**GoTriangle**  
**GoTriangle Durham Bus Stop Construction (Group J)**  
**IFB NO. 24-006**  
**Questions and Answers / Pre-Bid Meeting Minutes**

**Pre-Bid Minutes**

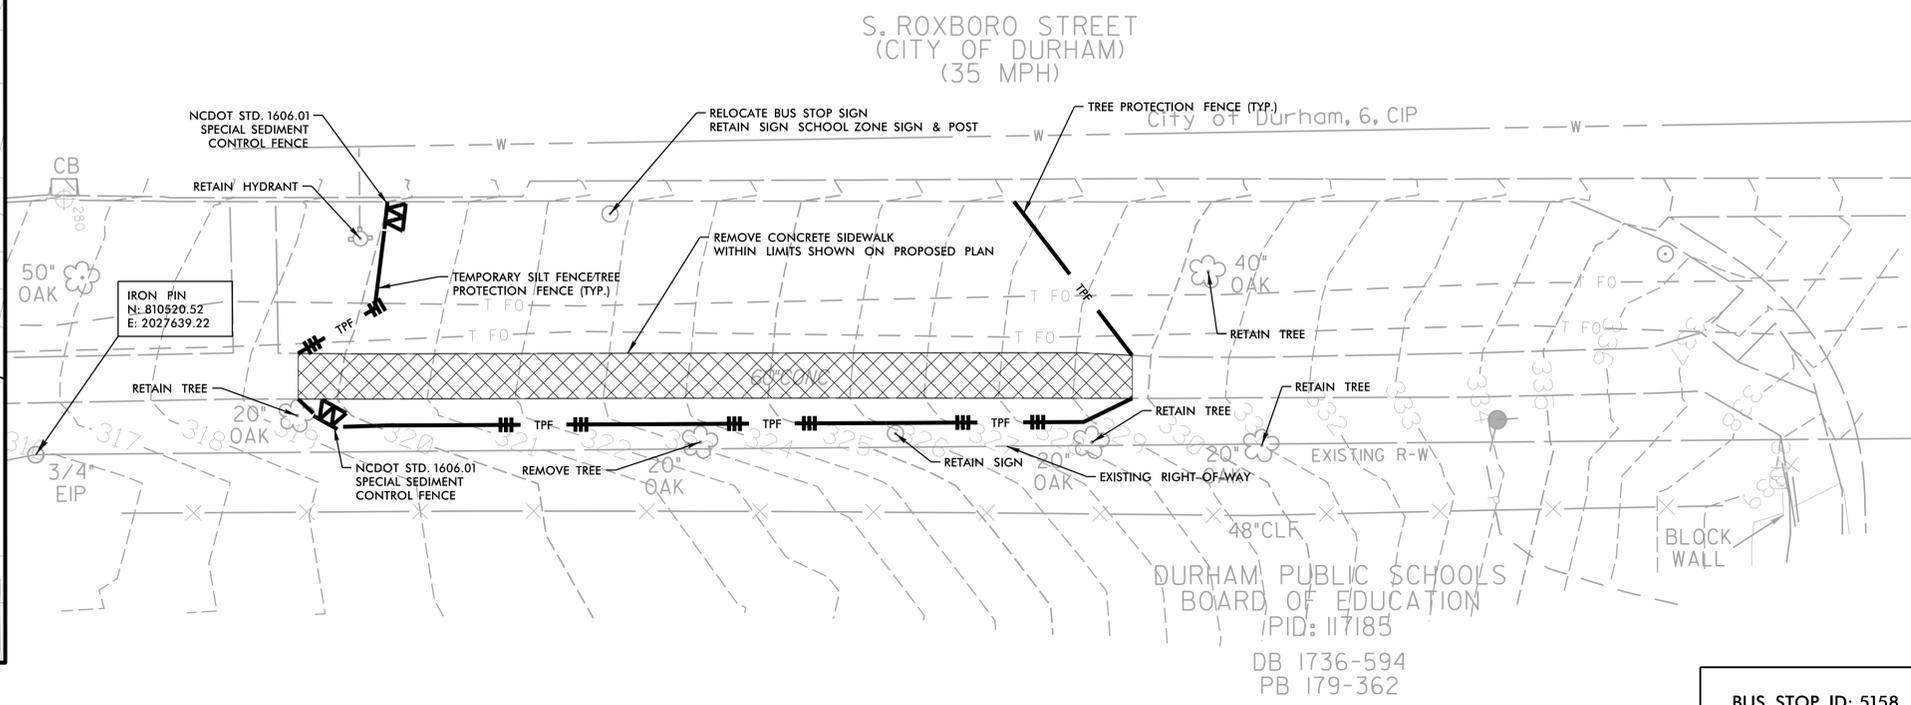
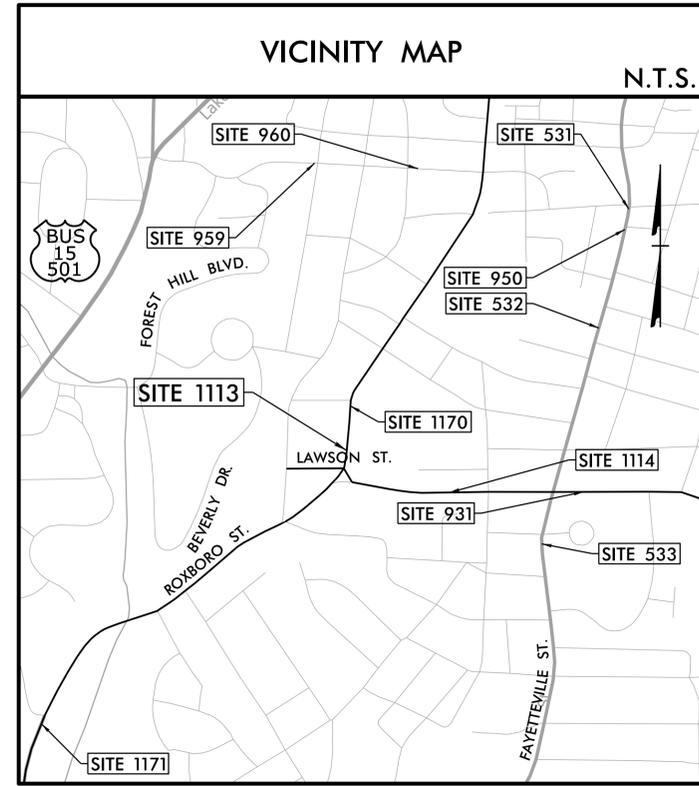
**On site No.1113, on Roxboro St. at Lawson St., there is an item listed for tree removal for an Oak tree (20"). There are Oaks on that site on the side of the sidewalk by the road. There are pine trees as well, on the other side, between the sidewalk and the existing chain link fence. It seems the one to be taken out, according to placement on the plans, is a pine, but called out as an Oak, which I feel is causing the confusion. Could you please provide clarity on this?**

**Answer: Survey notes is incorrect tree type (pine trees are labeled as Oaks). The tree intended to be removed is the multi-trunk pine.**

SITE NO.  
**1113.1**

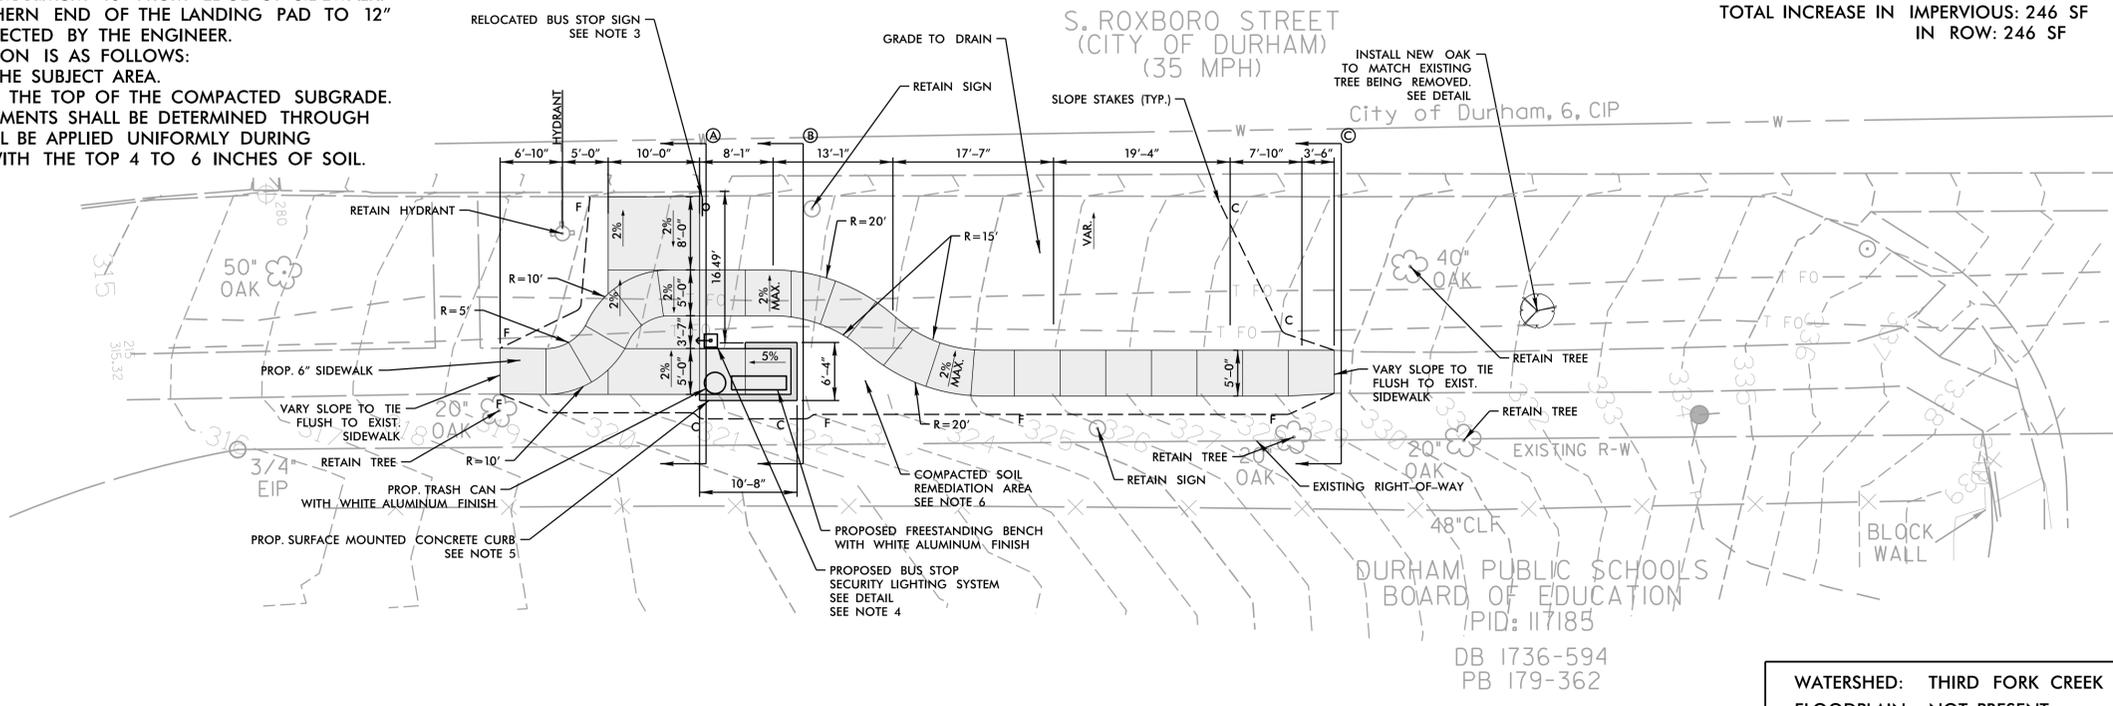
- e. **An addendum will be issued:**
  - i. **Meeting Minutes**
  - ii. **Revised Drawings for Solar Light: Site 619, 912, 932, and 944**
  - iii. **Revised Drawing for Site 1113**

SITE NO.  
**619**

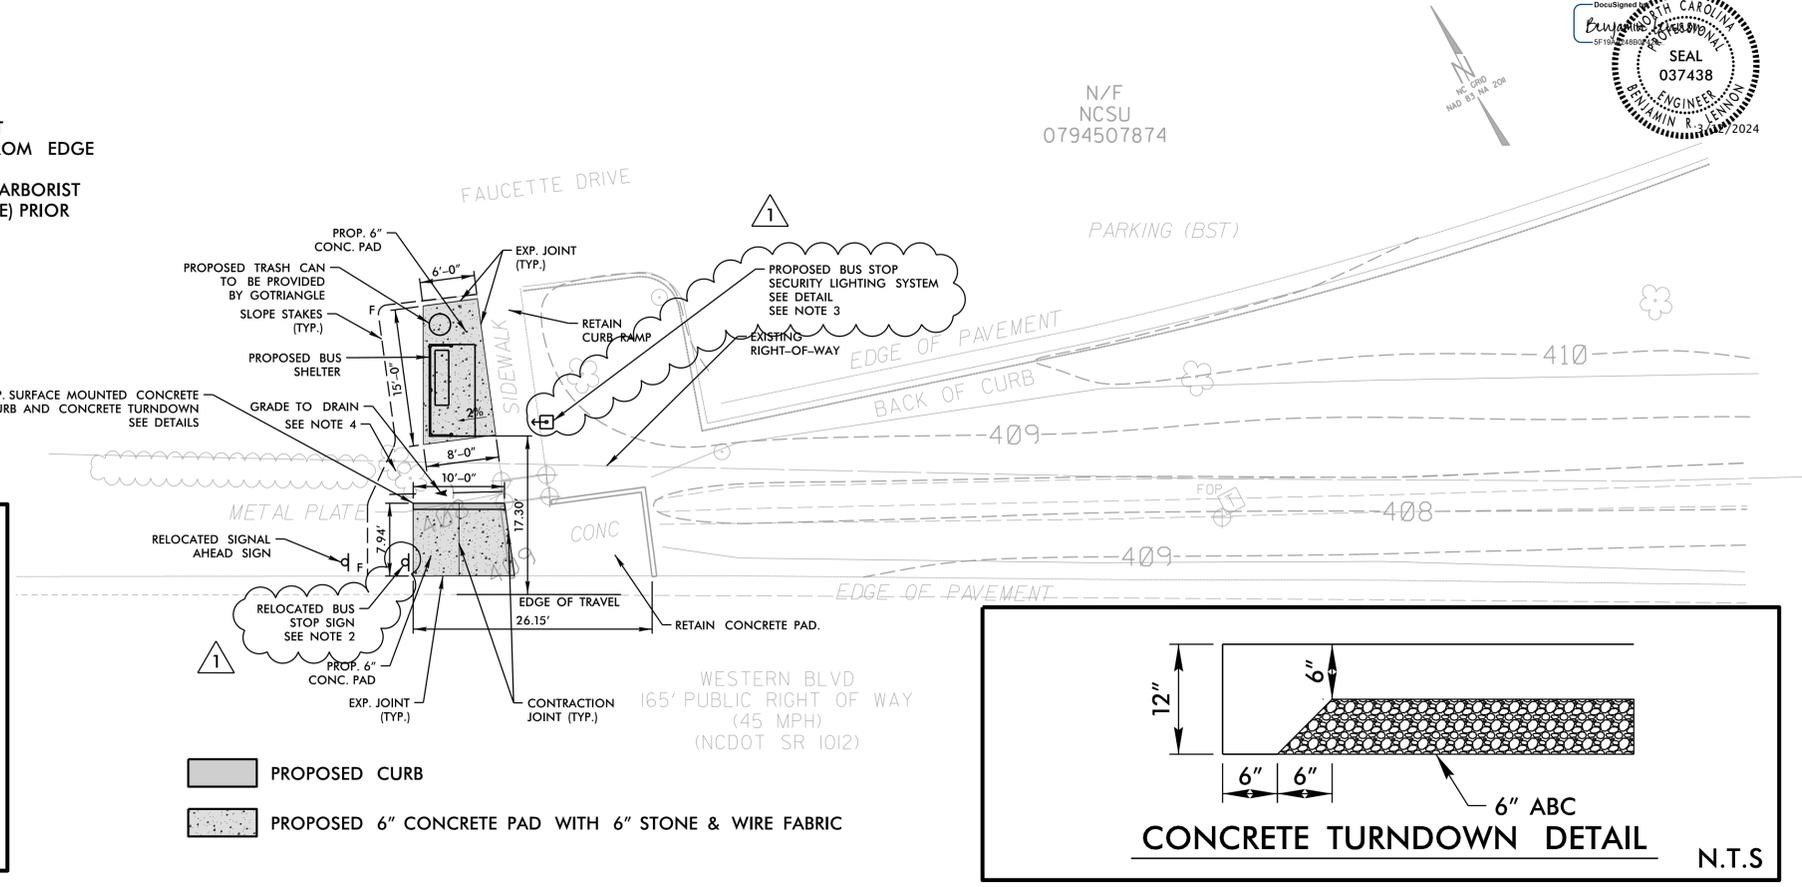
REVISIONS	DATE	DESCRIPTION
1	3/12/2024	RELOCATED SECURITY LIGHTING SYSTEM FROM BUS STOP SIGN POST TO A SEPARATE POST

The revised plans for sites 619, 912, 932, and 944 all have security lighting systems on separate posts from the bus stop sign as such sheet 2C-3 includes the details for security lighting installation.

SITE NO.  
**912**

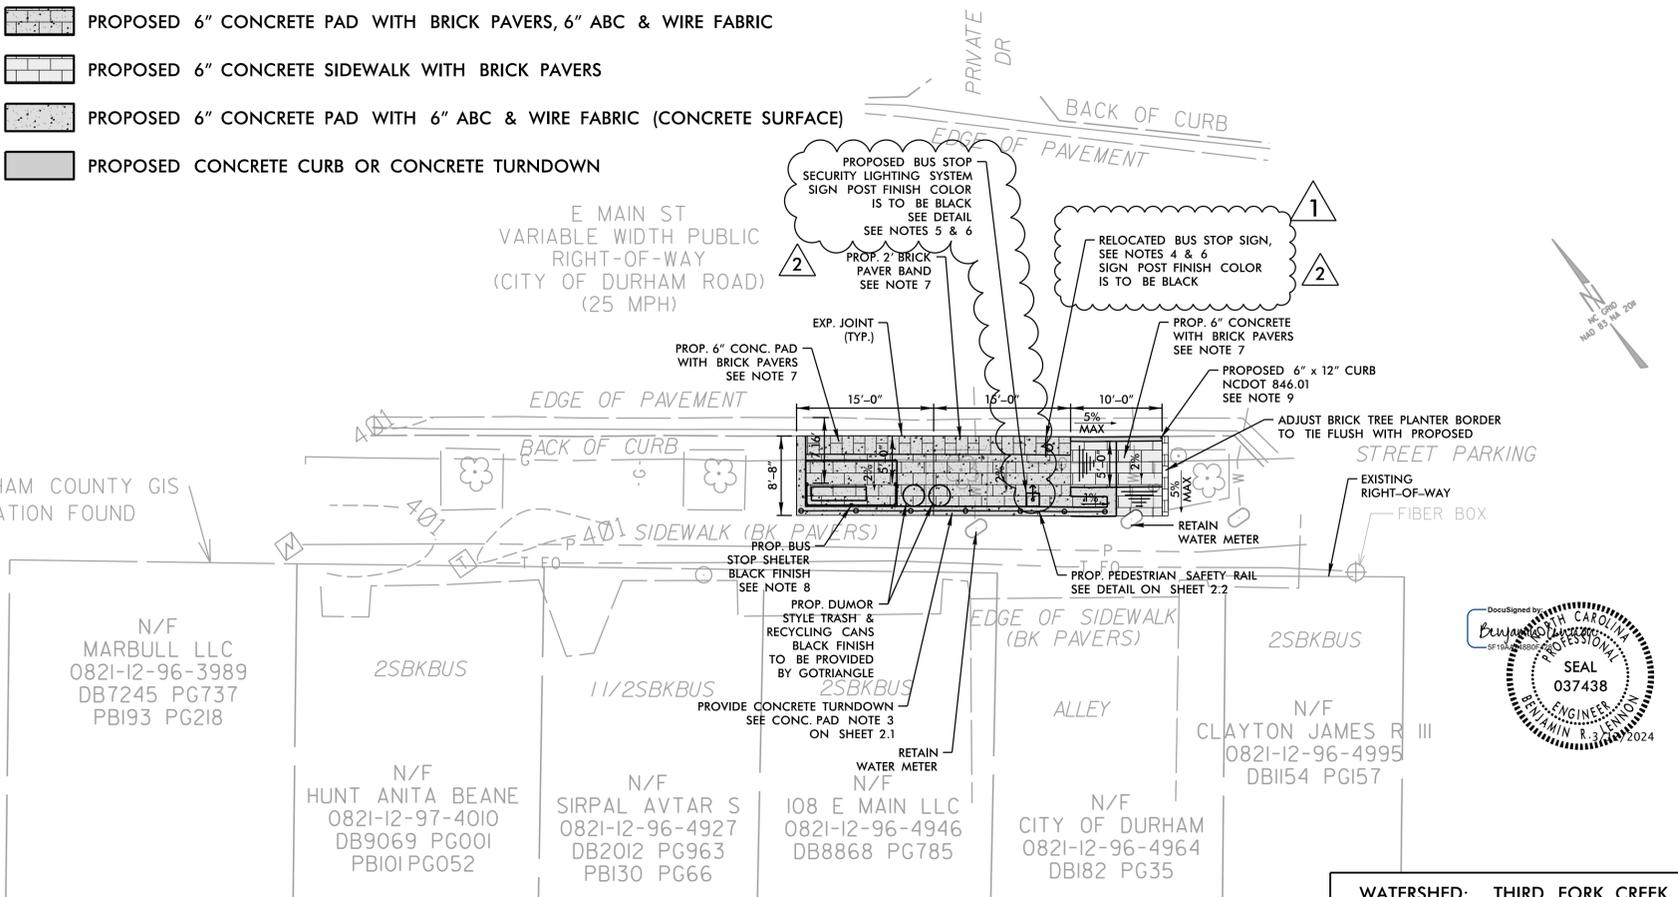
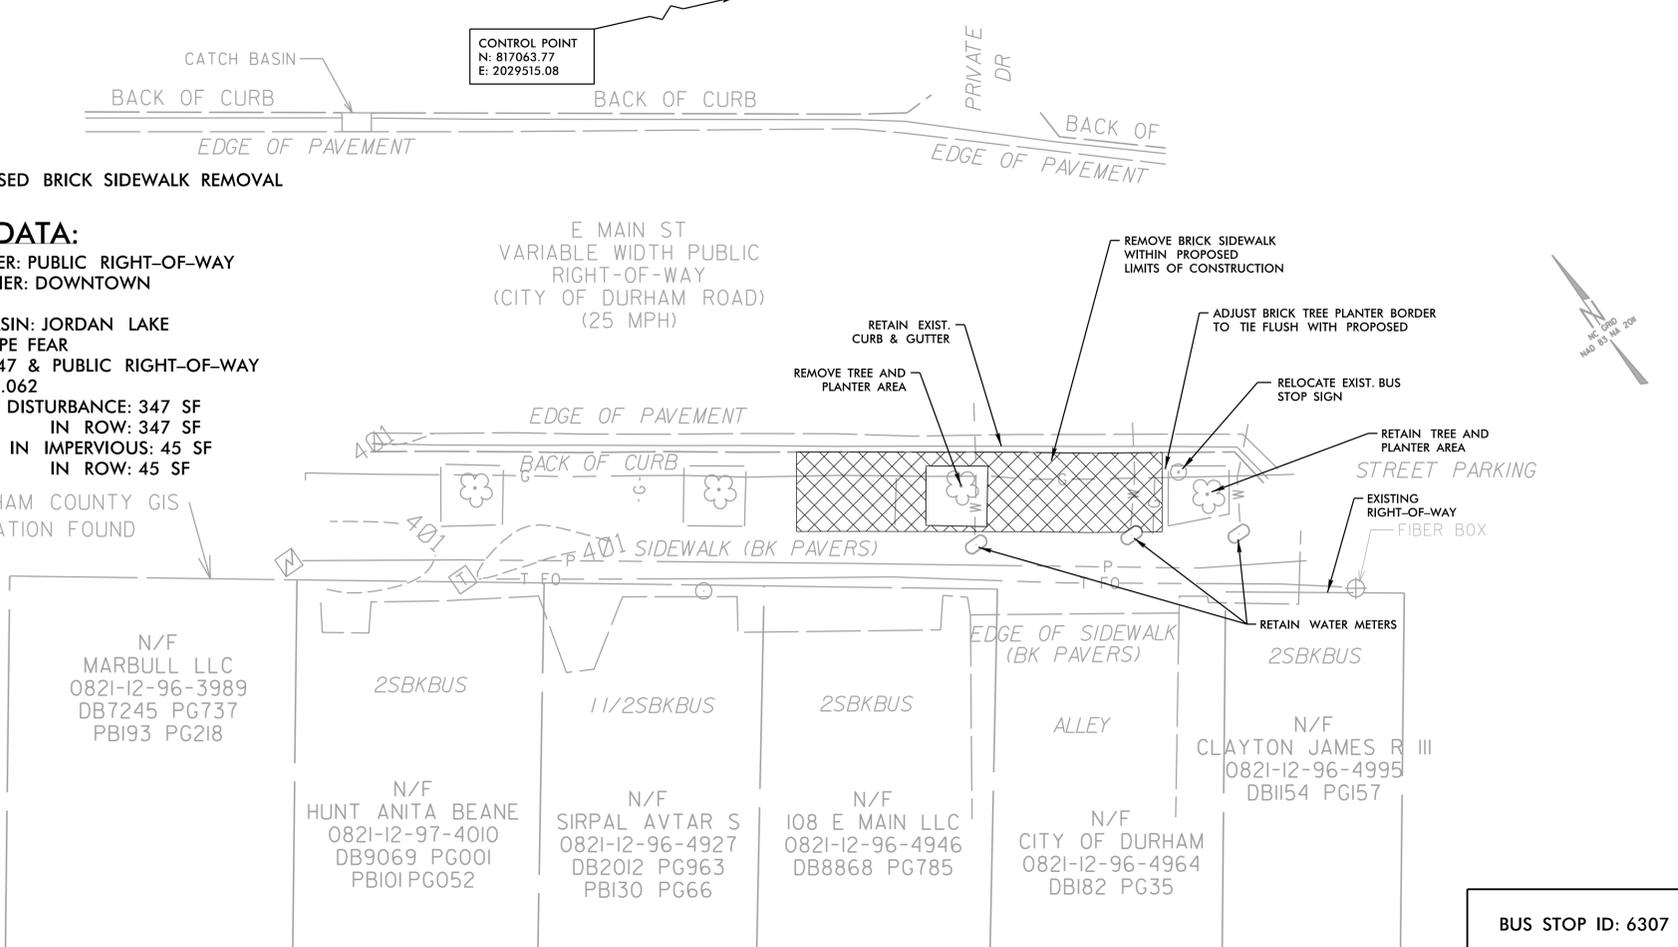
**Site 912 Note 6: core hole cost and how is it paid?**

**Note 5 on the Site 912 has the wrong reference Sheet 2.3 incorrect reference. Is the sheet 2B-2 the correct reference?**

01/22/2023	ADD LABEL FOR SIGN POST FINISH TO BE BLACK TO MATCH DISTRICT STANDARDS.
3/2/2024	RELOCATED SECURITY LIGHTING SYSTEM FROM BUS STOP SIGN POST TO A SEPARATE POST

**Answer: This will be incidental work to the relocation of bus stop sign.**

**Answer: Yes.**
